MONUMENT SERVICE UPGRADE 20021 BEACON LITE RD, MONUMENT, CO 80132

DATE	DESCRIPTION	BV
DAIE	DESCIMI HON	ח ש
08-18-17	ISSUED FOR REVIEW	EGP
08-22-17	ISSUED FOR REVIEW	EGP
08-24-17	ISSUED FOR PERMIT	EGP
09-22-17	ZONING SUBMITTAL	RFA

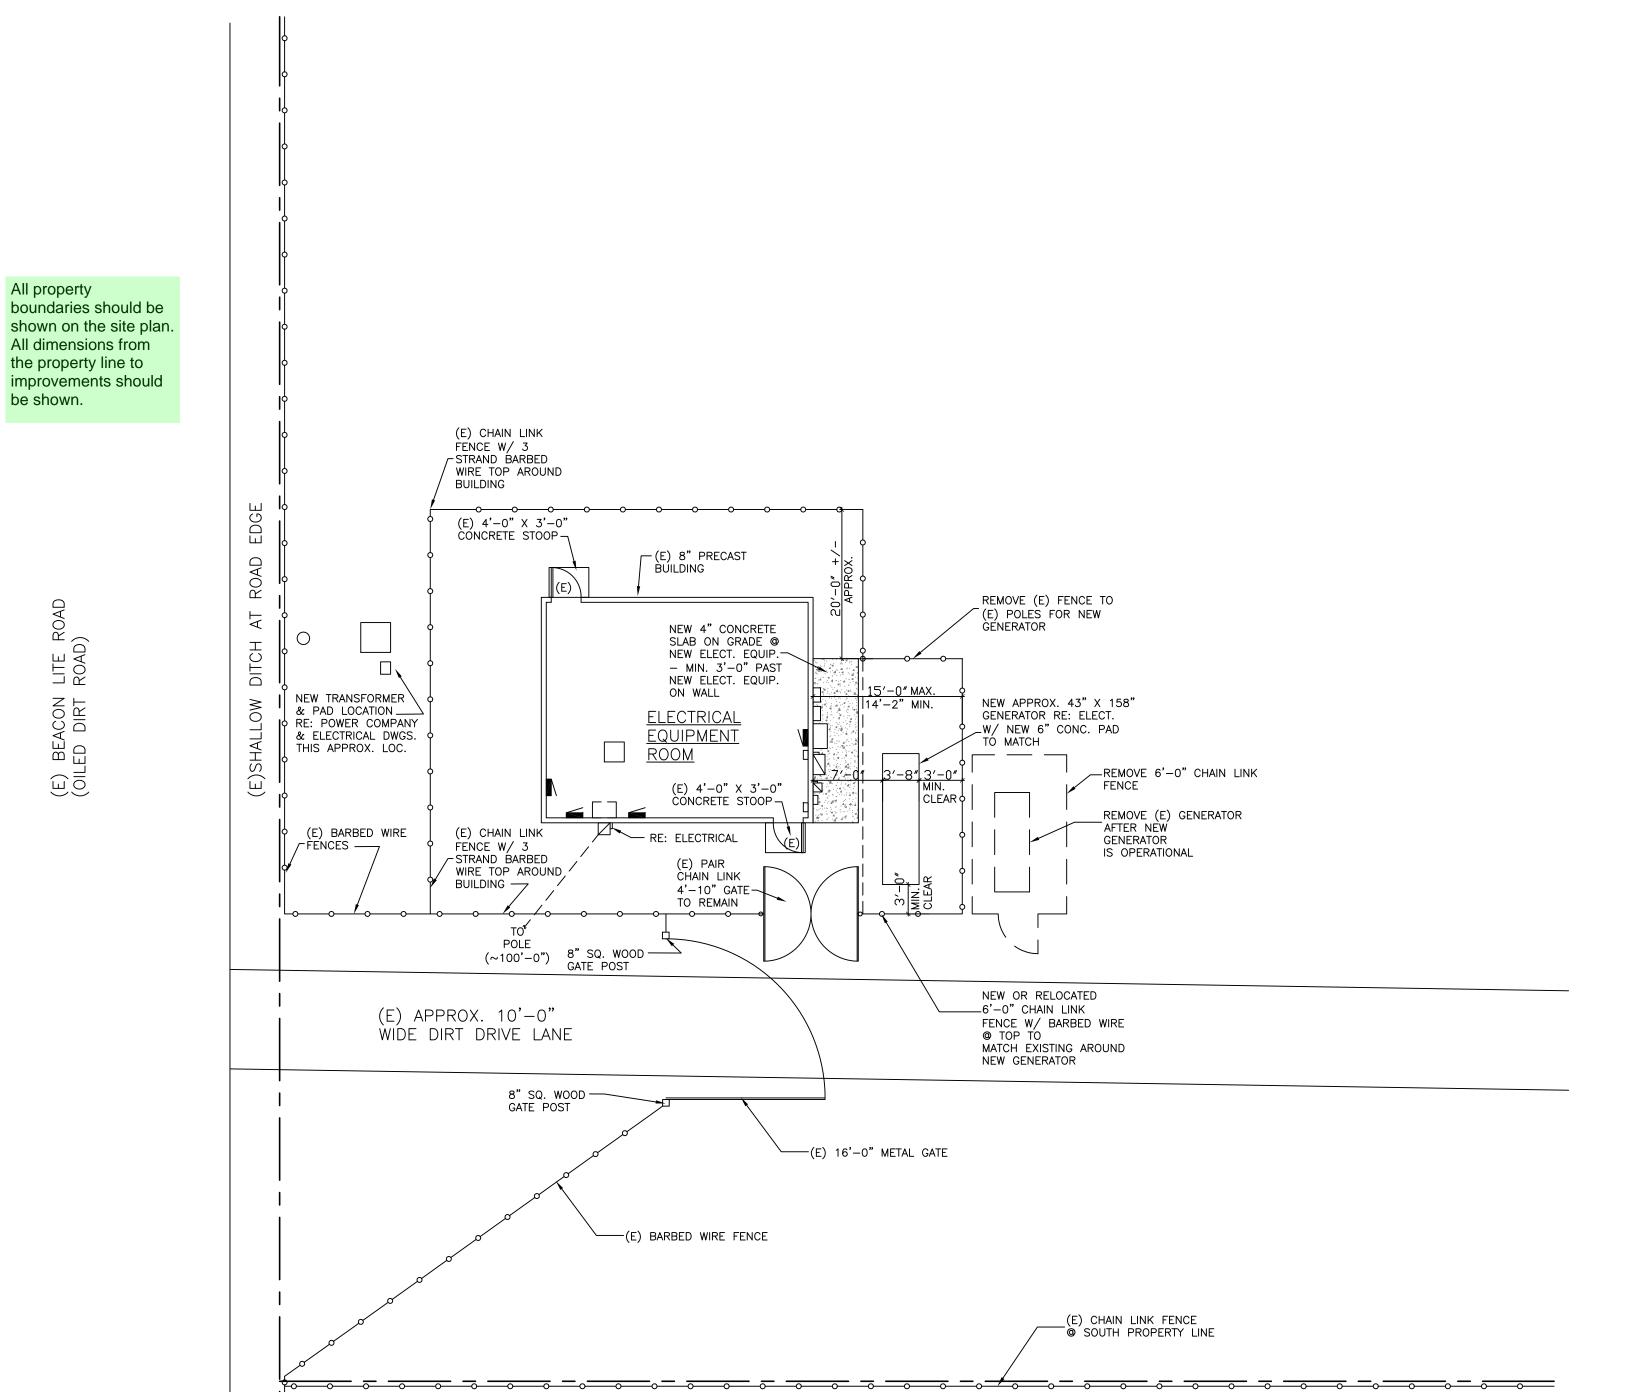
All property

be shown.

All property boundaries should be shown on the site plan All dimensions from the property line to improvements should be shown. Subject: Text Box Page Label: 2 Lock: Locked Author: dsdruiz

SHEET TITLE: FLOOR PLAN- POWER SHEET NO. O8-18-17 L10 EGP#17148.00		
OR P OWI	SHEET	TITLE:
	FLOOR	PLAN - VER
08-18-17 PROJECT NO. EGP#17148.00	SHEET NO.	DATE:
PROJECT NO. EGP#17148.00		08-18-17
EGP#17148.00	L10	PROJECT NO.:
		EGP#17148.00

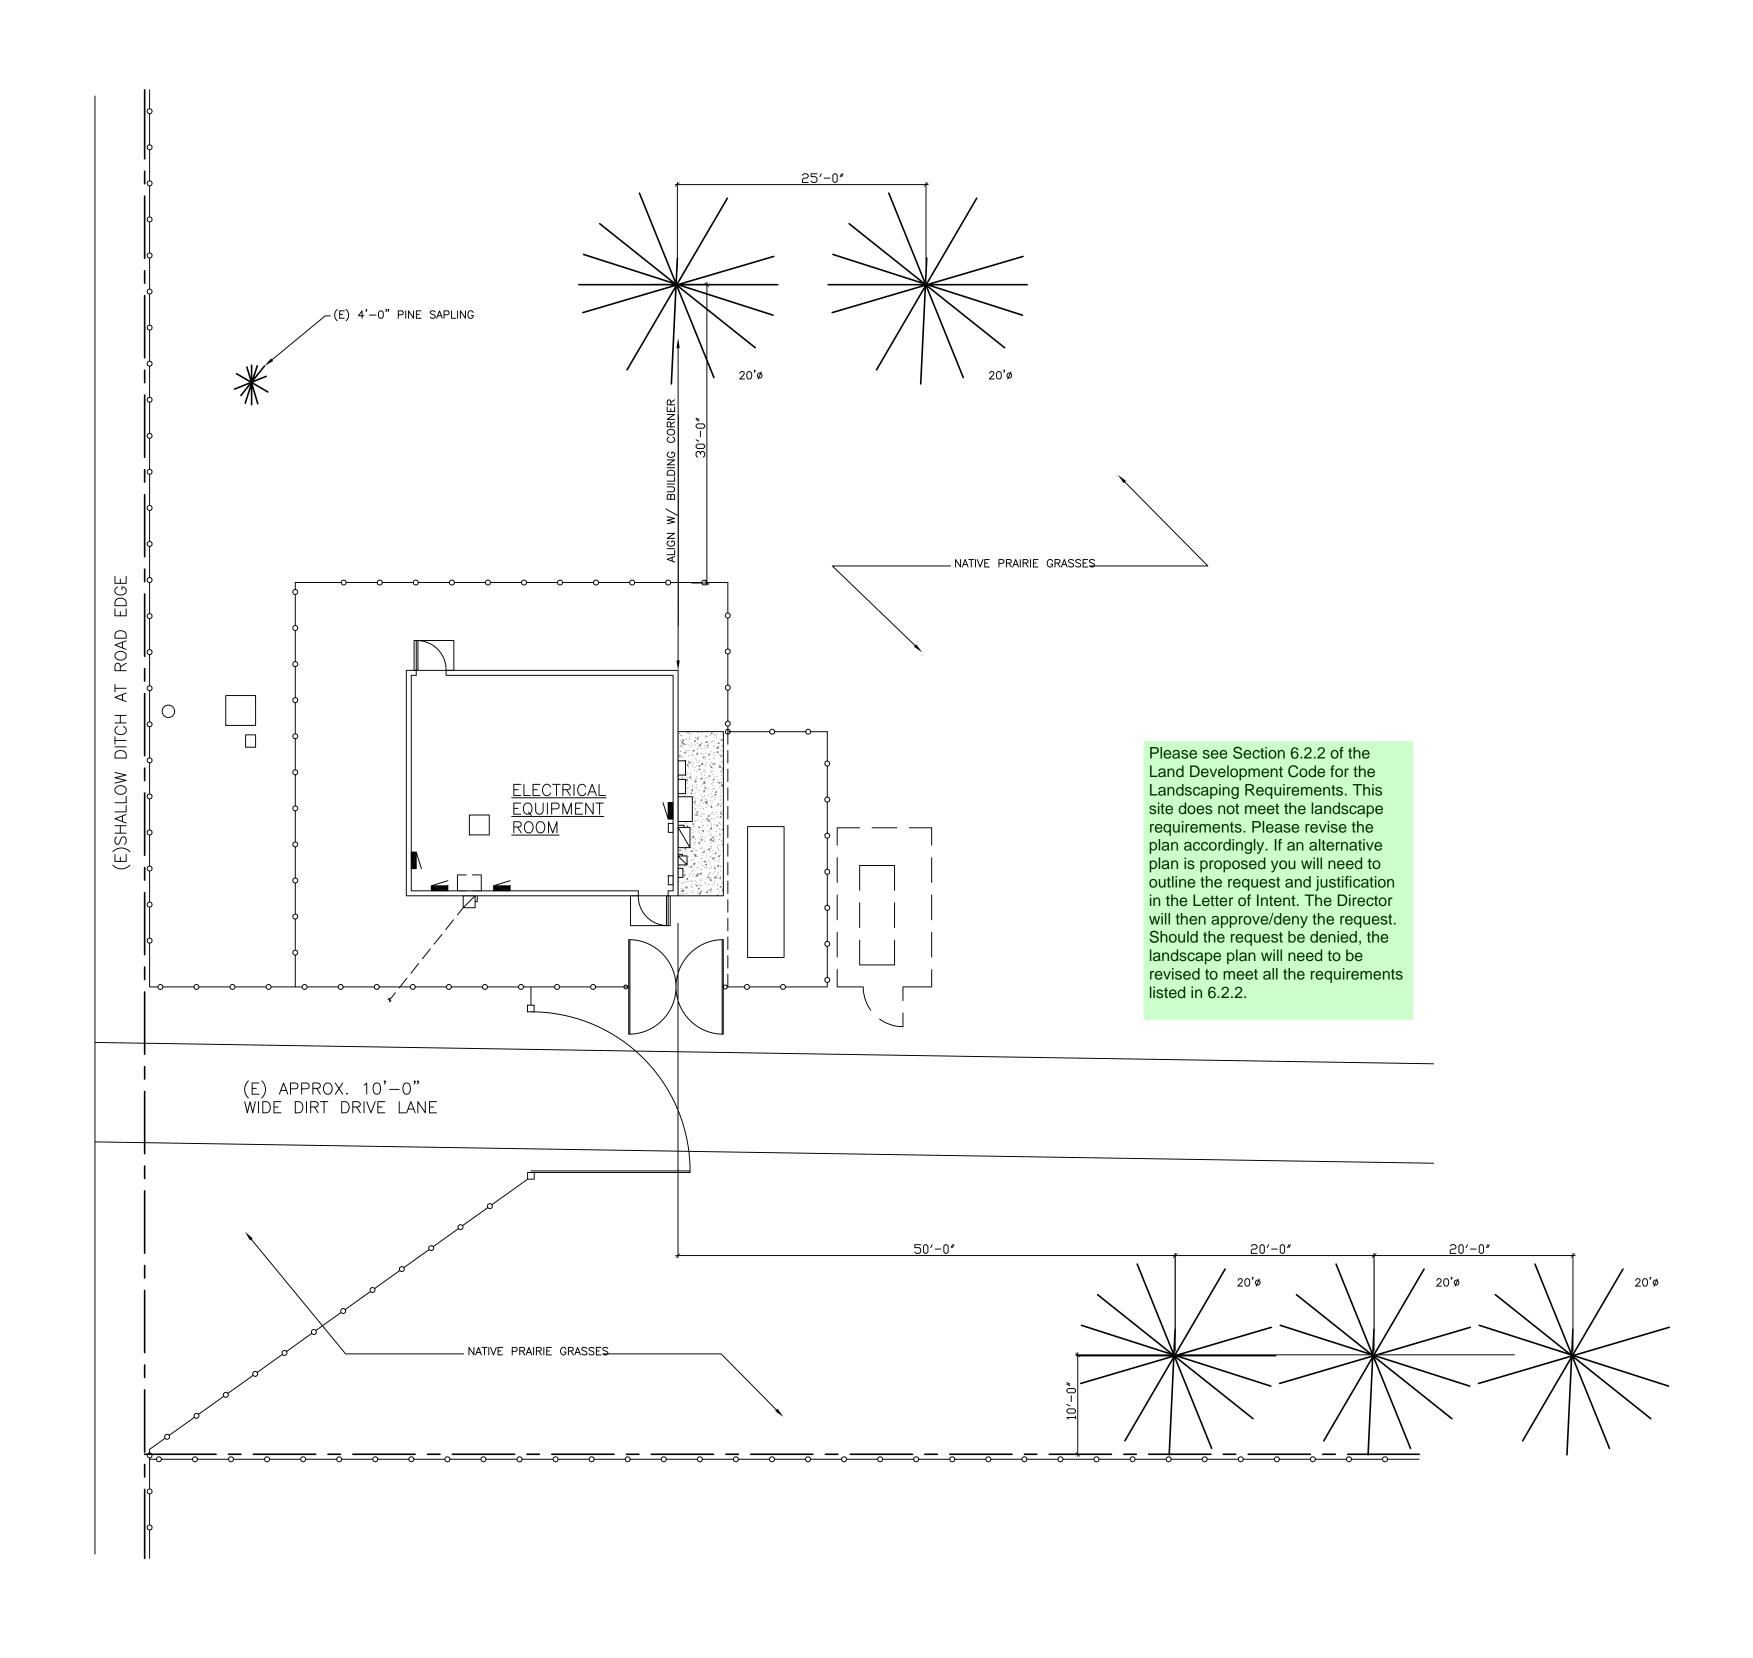
Please see Section 6.2.2 of the Land Development Code for the Landscaping Requirements. This site does not meet the landscape requirements. Please revise the plan accordingly. If an alternative plan is proposed you will need to outline the request and justification in the Letter of Intent. The Director will then approve/deny the request. Should the request be denied, the landscape plan will need to be revised to meet all the requirements listed in 6.2.2.
